DESCRIPTIVE REPORT

Registry No. H-11065

Descriptive Report to Accompany Hydrographic Survey H11065

Project OPR-P182-RA-01¹
Southwest Alaska Peninsula and Semidi² Islands, Alaska
Scale 1:10,000
July-August 2001
NOAA Ship RAINIER
Chief of Party: Captain James C. Gardner, NOAA

Atkulik Island

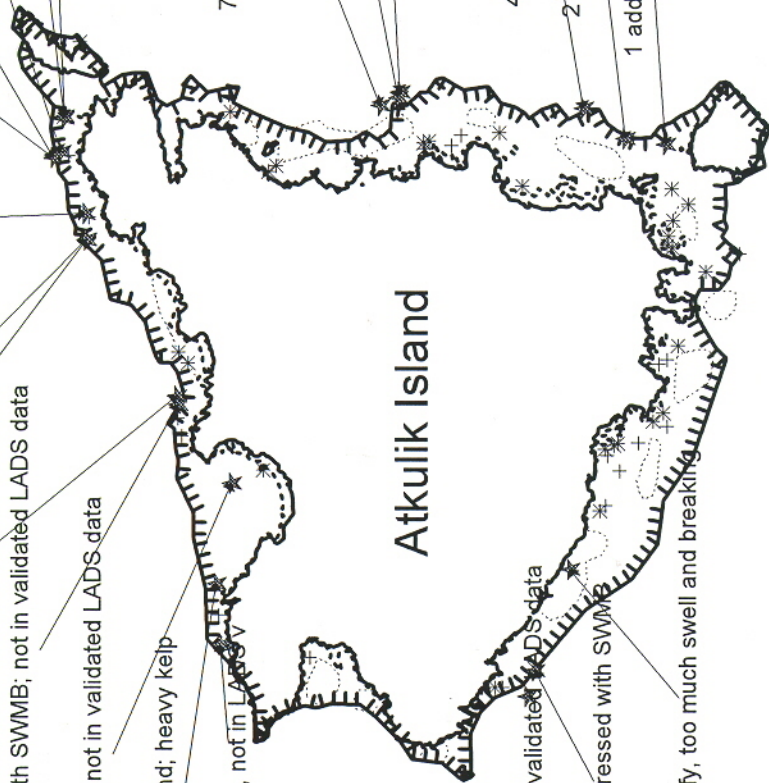
The following soundings may be LADS noise returns (ie kelp or fish) but are considered worthy of examination in order to positively confirm or disprove them. This could be conducted by surface vessel (or LADS at 2x2 or 3x3 meter laser spot spacing).

- 11 addressed with SWMB; not in validated LADS data
- 20 addressed (disproved?) with single-beam & SWMB; heavy ke
- 21 disproved (?) with single-beam & SWMB; heavy ke

- 16 disproved (?) with single-beam & SWMB; heavy ke
- 22 addressed w/SWMB; not in validated LADS data (18 disproved with SWMB; not in validated (22?))
- 19 addressed with SWMB, hol10m; not in validated LA

- 17 kelp, unable to address, rk 10m away disprvd w/
- 23 kelp, unable to address, rk 10m away disprvd w/
- 12 addressed with SWMB; not in validated LADS data

- 14 addressed with SWMB, not in validated LADS data
- 10 addressed w/SB, no rock found; heavy kelp
- 13 addressed with SWMB(hol4m), kelp, not in validated LADS data

- 7 addressed with SWMB; not in validated LADS data
- 8 addressed with SWMB; not in validated LADS data
- 9 addressed with SWMB; not in validated LADS data

- 6 addressed with SWMB, not in validated LADS data
- 3 disproved (SB?), addressed with SWMB
- 4 disproved with single-beam, SWMB dev planned
- 2 addressed with SWMB; not in validated LADS data

- 1 addressed w/ SWMB; 3.4 nearby, too much swell
- 5 too close to verify, too much swell and breaking

15 not in validated LADS dataset, hol w/in 5m, dev
